To: Ridgeland WRF Expansion Plan Holders

Re: Addendum #3
Ridgeland WRF Expansion

The purpose of this project is to replace the existing wastewater lagoons with an SBR treatment system. The capacity of the plant is also being expanded, and a new operator building is being constructed. Presently, the system discharges to a sod farm; the new facility will discharge to nearby Captain Bill's Creek.

SHEET NO. **E001** OF ---
 FILE NO. **1636.6**

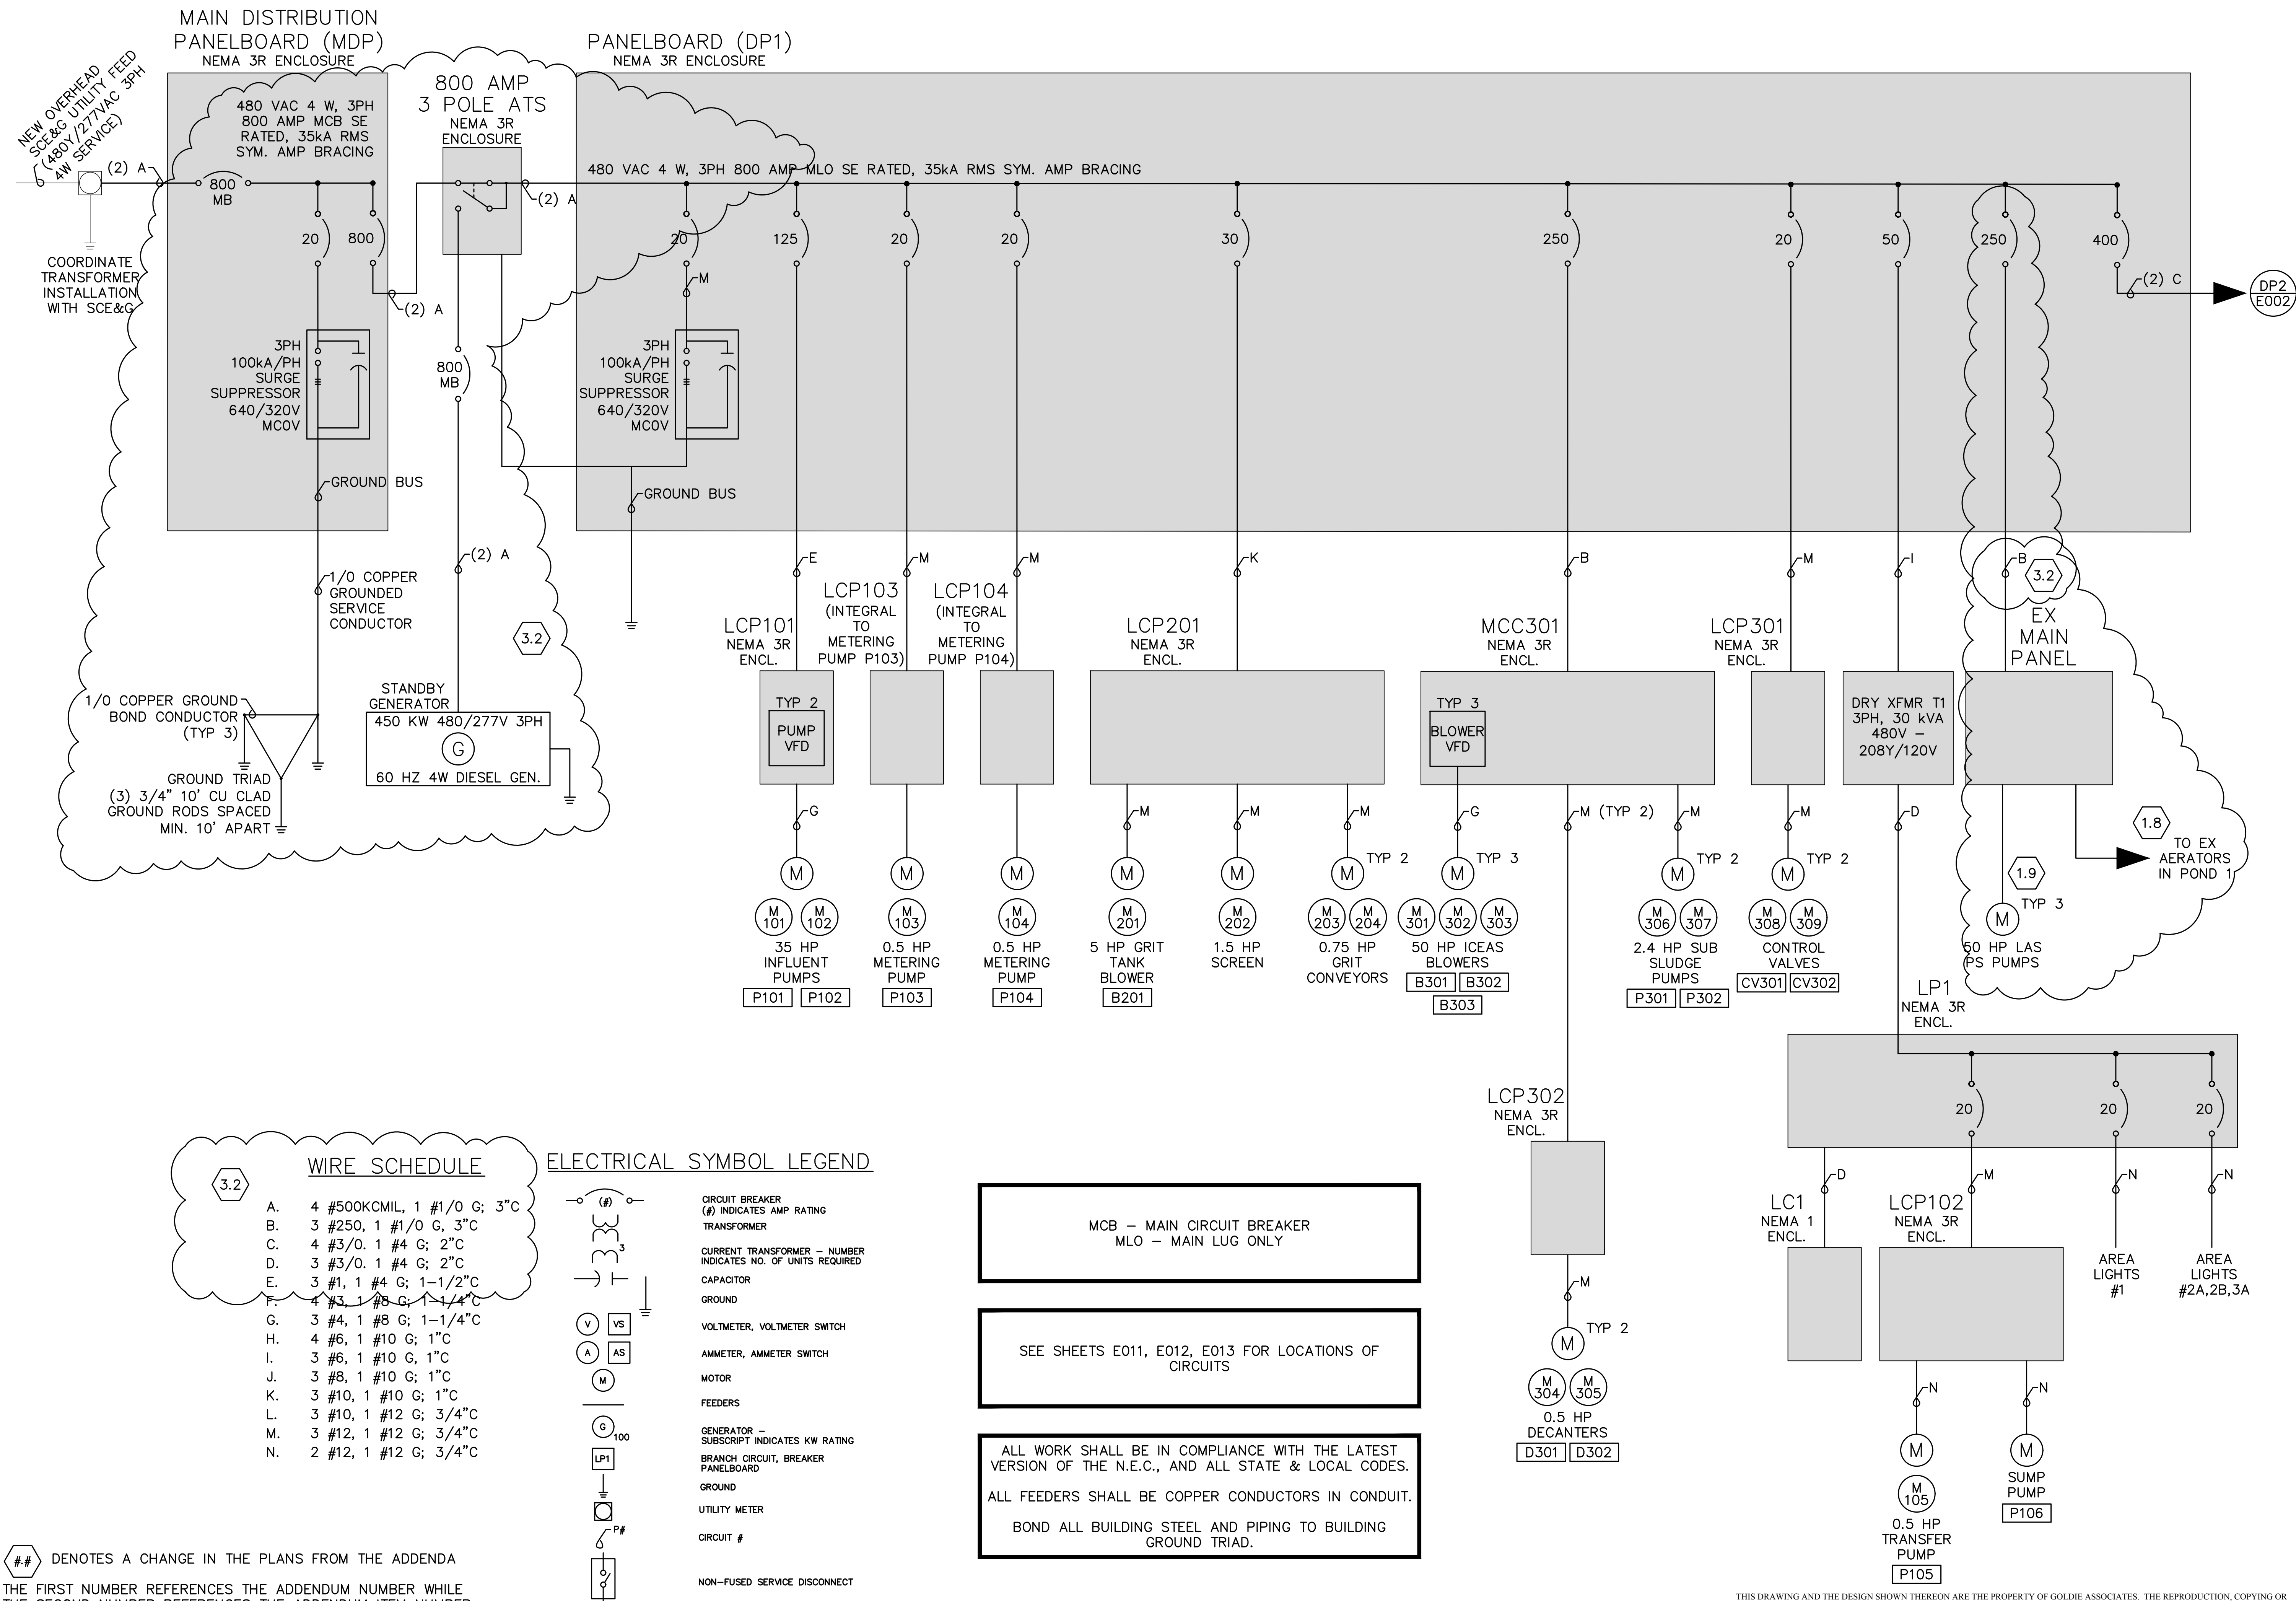
3.2	E001 One-line diagram	<ol style="list-style-type: none"> 1. MDP, DP1, ATS - Upgrade these to 800A to accommodate increased load from LAS pumps. 2. Wire schedule – Update wire schedule: <ol style="list-style-type: none"> a. A - 500 KCMIL with Ground wire 1/0. b. B – Ground wire to 1/0 c. C – Ground wire to #4. d. D – Ground wire to #4. e. E – Ground wire to #4. 3. Upsize generator to 450 KW. 4. Wire size to existing main panel is wire size B. 5. Update plan sheet is attached.

SHEET NO.	OF
E002	---
FILE NO.	1636.6

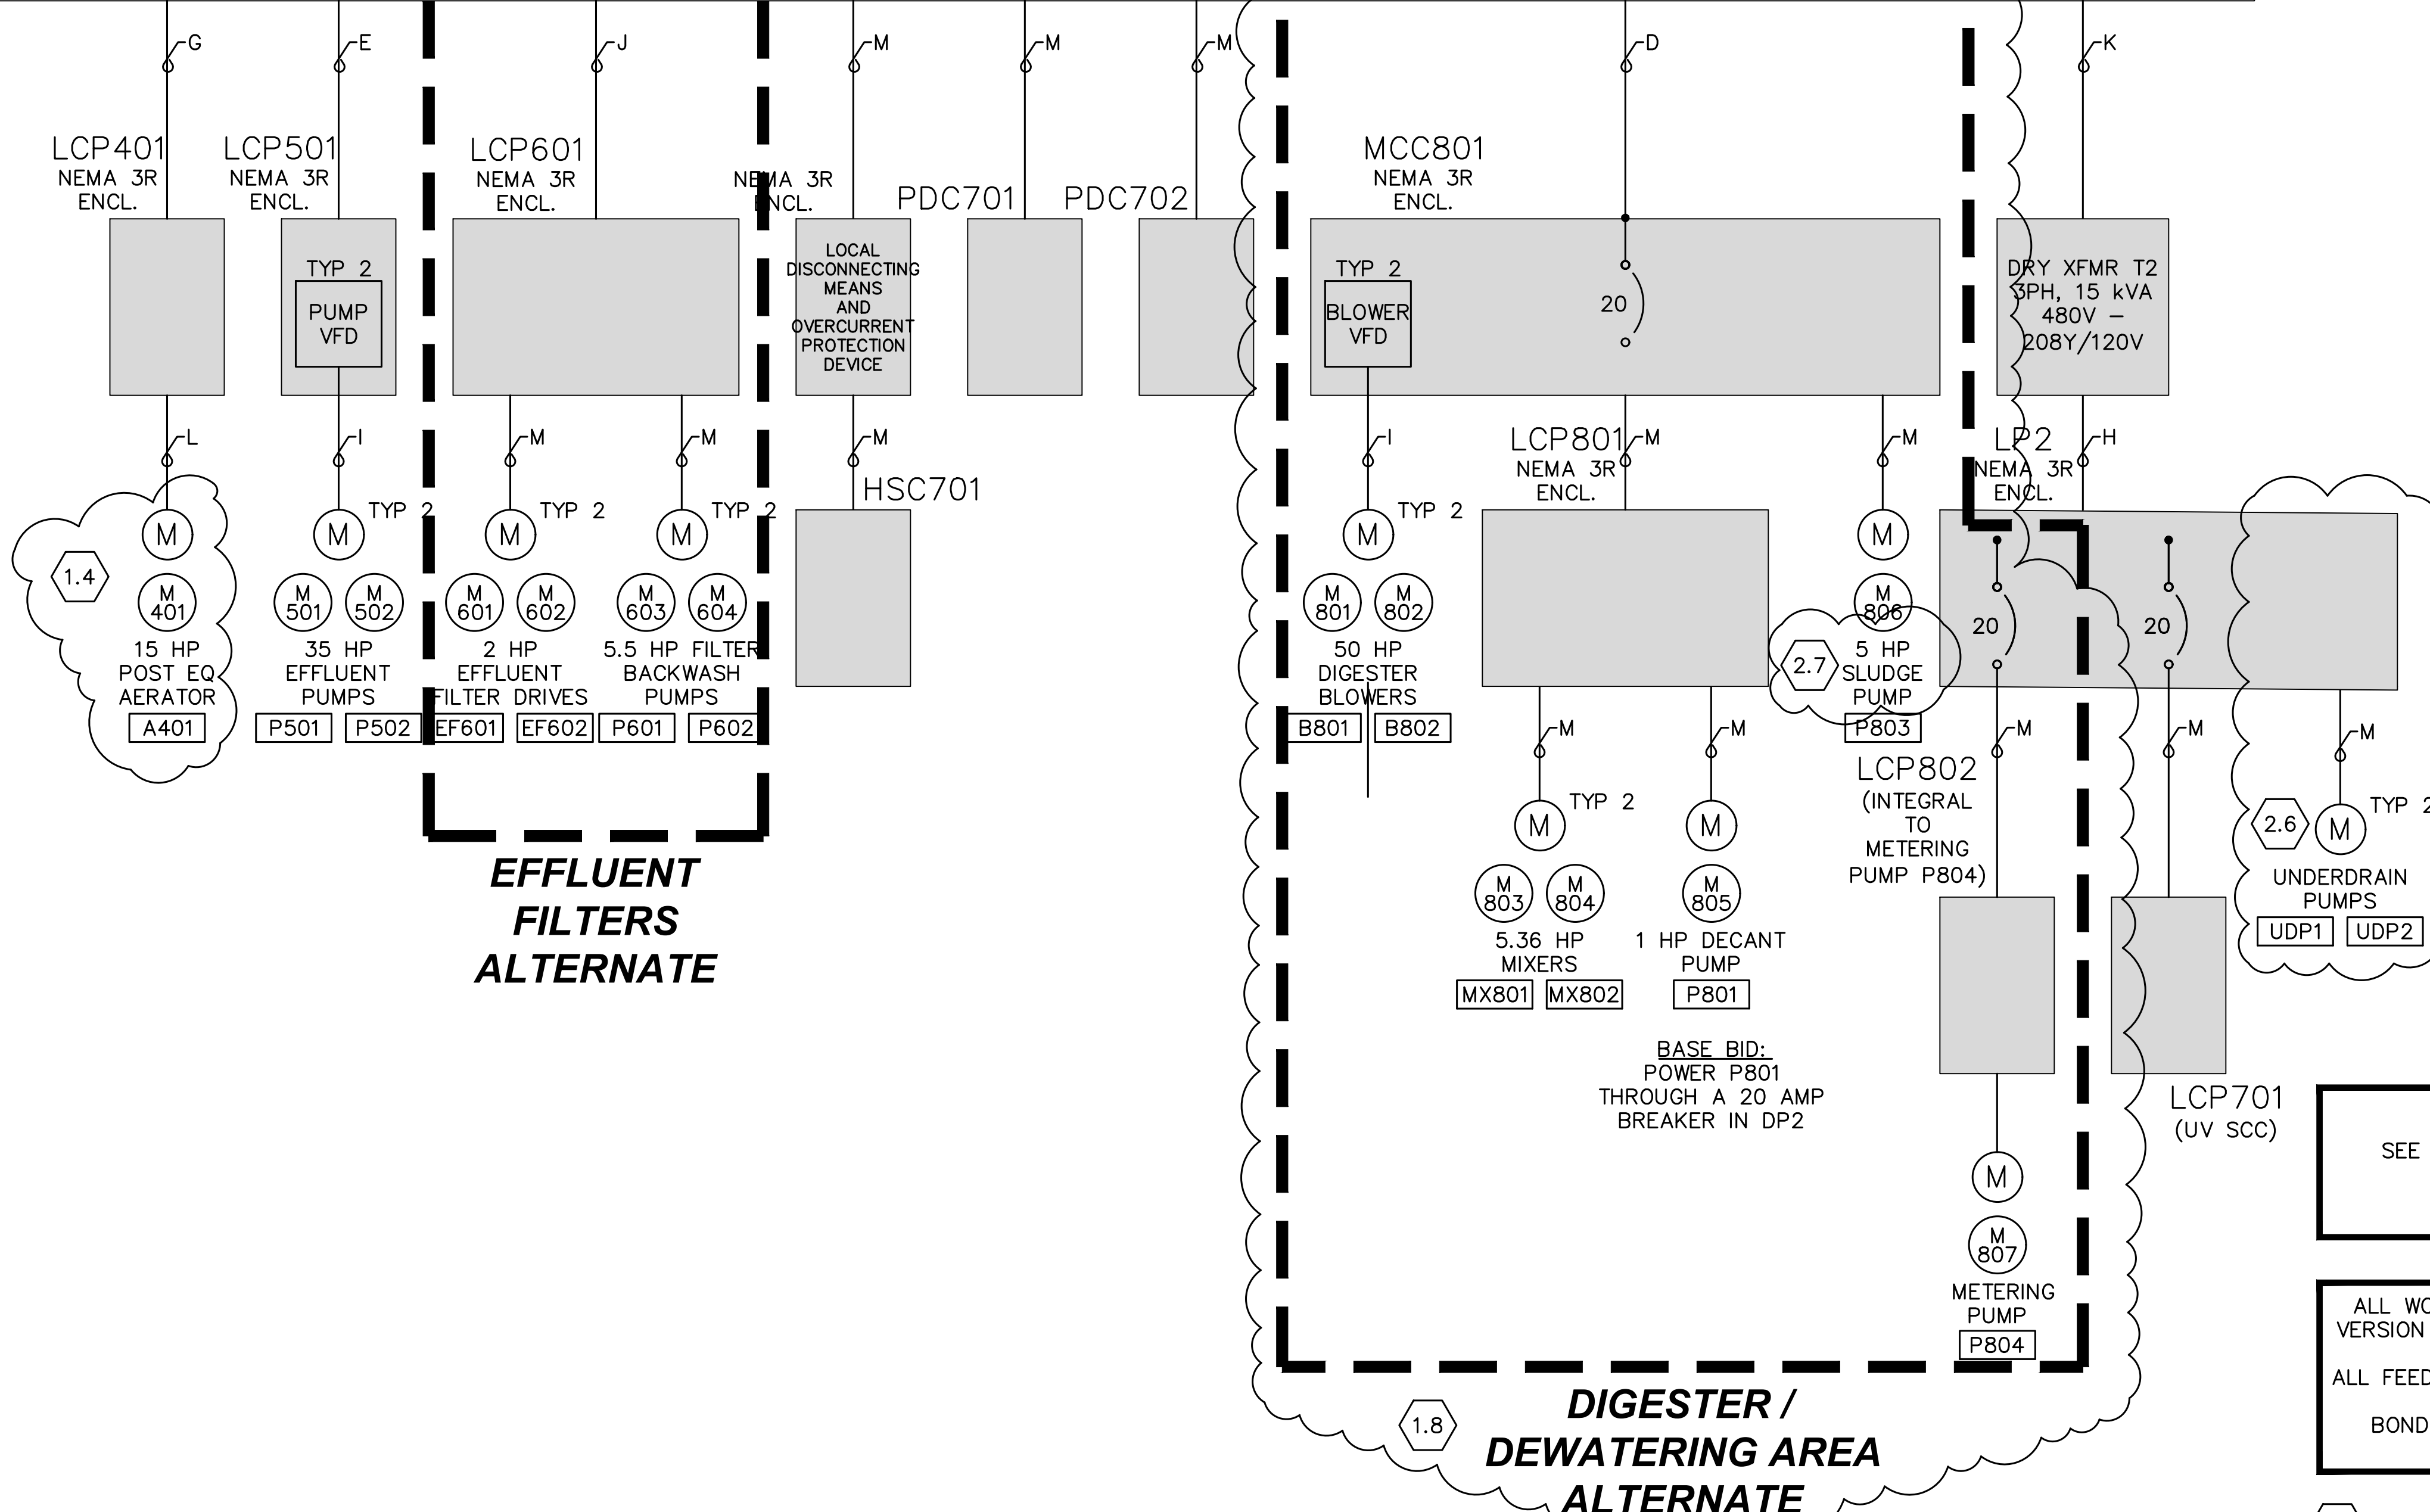
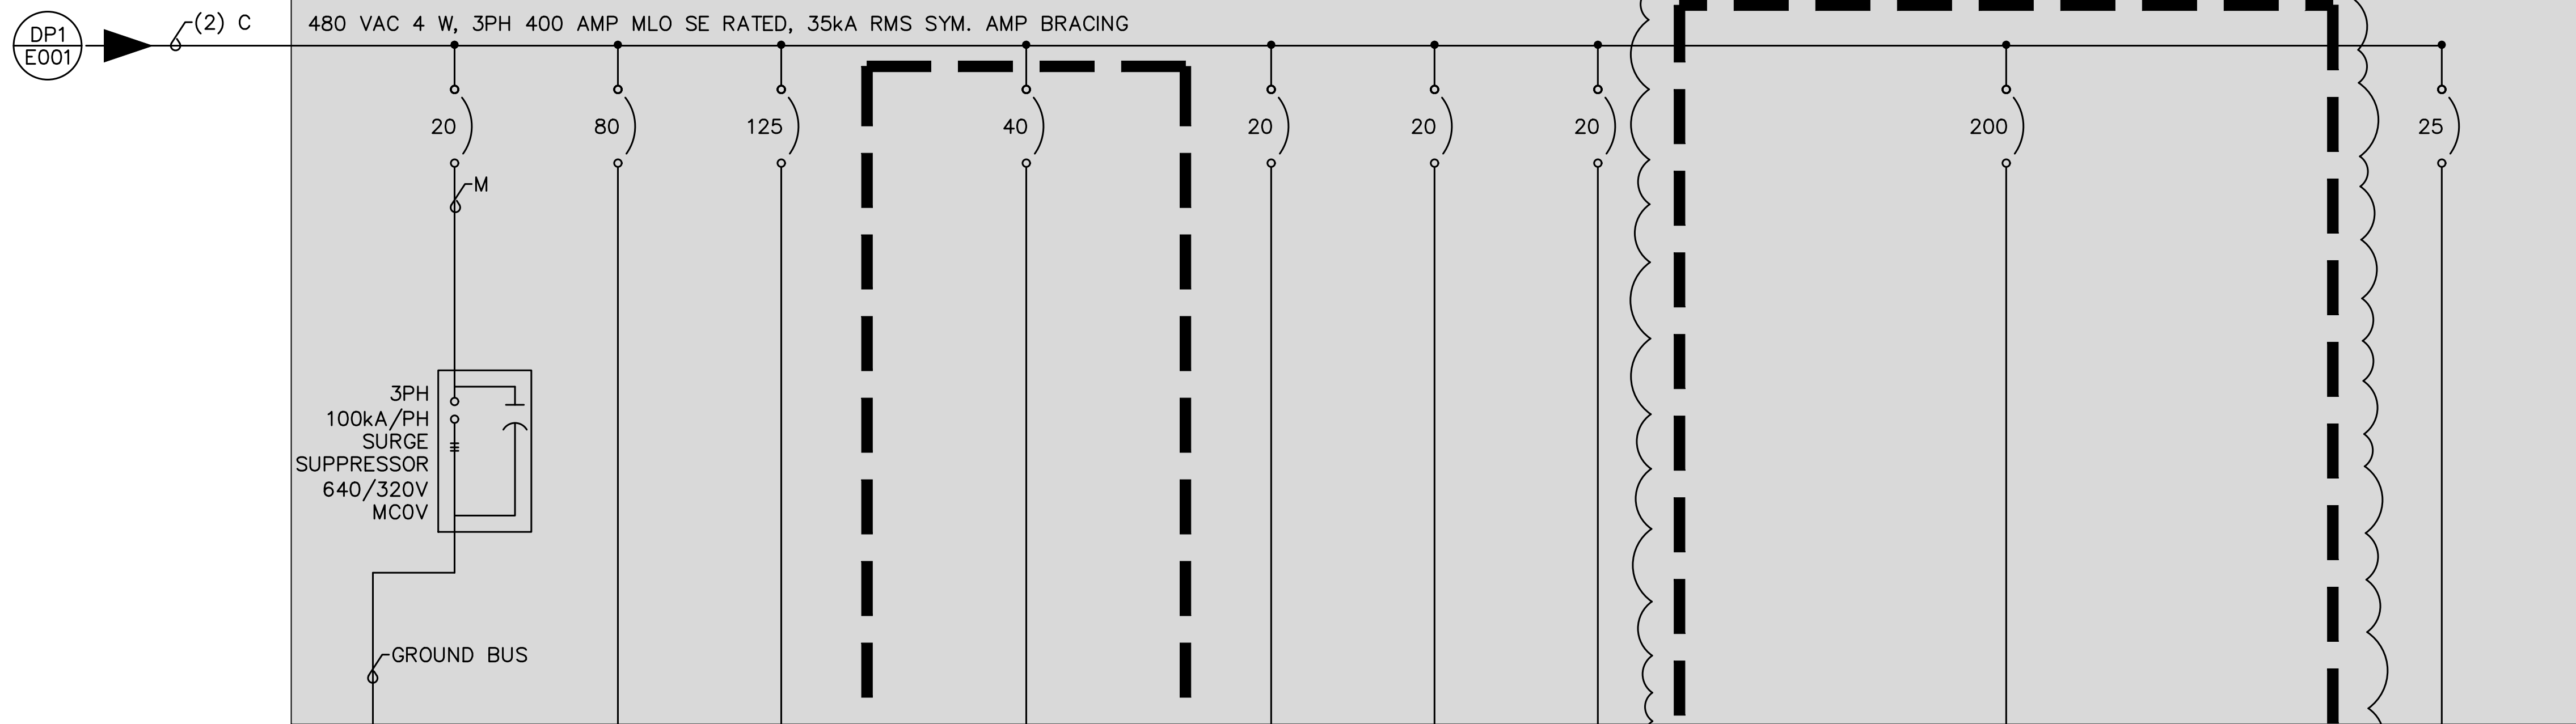
3.3	E002 One-line diagram	<ol style="list-style-type: none"> 1. Sludge pump P803 / motor 806 - There is not a change in the wire size for upgraded 5 hp pump. It remains wire size M. 2. Underdrain pumps - Use M on the wire schedule. 3. Update wire schedule as shown in 3.2. 4. Updated plans sheet is attached.
